PROJECT
PROPOSED CONVERSION OF CAPEL GROES, HILL CLOSE, PENYCAE. WREXHAM. LL14 2DR

DETAIL
PLANNING DRAWING. PROPOSED ELEVATION 3 & 4

SCALE 1:100 REV A
Drg No: 0112/06 DATE 16/10/14

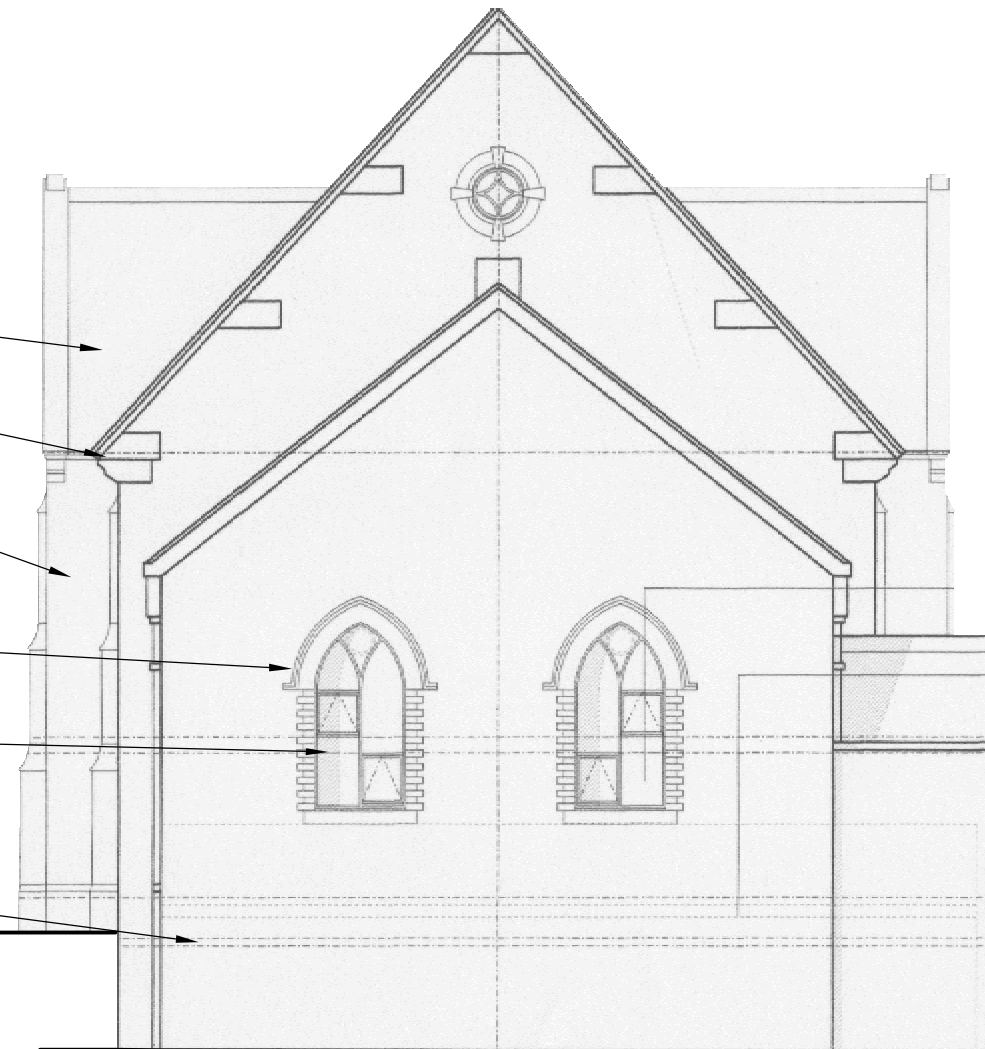
REV A DATE 19/04/15
AMENDMENTS TO SUIT PLANNING COMMENTS, THUS:
